ND-15-0903  
10 CFR 50.90

Southern Nuclear Operating Company  
Vogtle Electric Generating Plant Units 3 and 4  
Request for License Amendment:  
Use of AWS D1.1-2000 Criteria for Structural Welds (LAR-15-009)

**Request for License Amendment Regarding**  
**Use of AWS D1.1-2000 Criteria for Structural Welds**  
**(LAR-15-009)**

Figure 1. Fillet Weld Loading in Plane of Weld

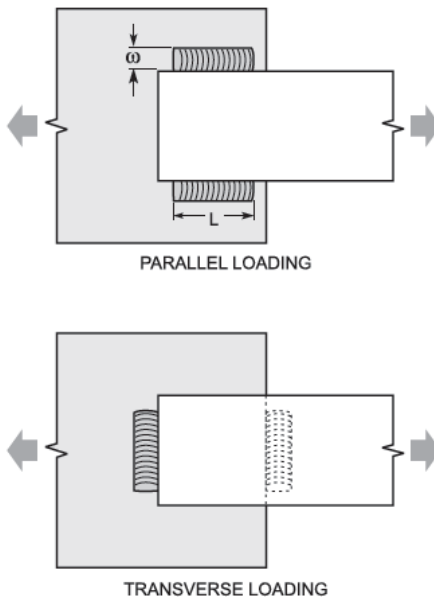
These changes are supported by industry tests that provide the justification for criteria that consider the load directionality. The testing and analysis is reported in an AISC Journal Article, “*Proposed Working Stresses for Fillet Welds in Building Construction*,” by T. R. Higgins and F.R. Preece. The referenced Higgins and Preece paper, describes tests on fillet welds loaded both parallel to and transverse to the axis of the weld in the plane of the weld, as illustrated in Figure 1. The Higgins and Preece paper provides a factor of safety summary related to a working stress of  $0.30F_{EXX}$ . The summary of test results demonstrates that the failure of the weld loaded transverse to the axis of the weld is approximately four times  $0.30F_{EXX}$ .

While the testing performed by Higgins and Preece was for weld groups loaded in the plane of the weld group elements, testing by Gomez et al. (Gomez, I., Kanvinde, A., Kwan, Y.K. and Grondin, G., “*Strength and Ductility of Welded Joints Subjected to Out-of-Plane Bending*,” Final Report to AISC, University of California, Davis, and University of Alberta, July 2008) confirms that the strength increase defined in AWS D1.1-2000 Section 2.14.4 does not have to be restricted to loads in-plane with the axis of the weld group. Fillet welds loaded out-of-the-plane of the weld group were studied using cruciform-shaped configurations as illustrated in Figure 2. A purpose of the study was to determine if the effect of loading parallel to the root notch or
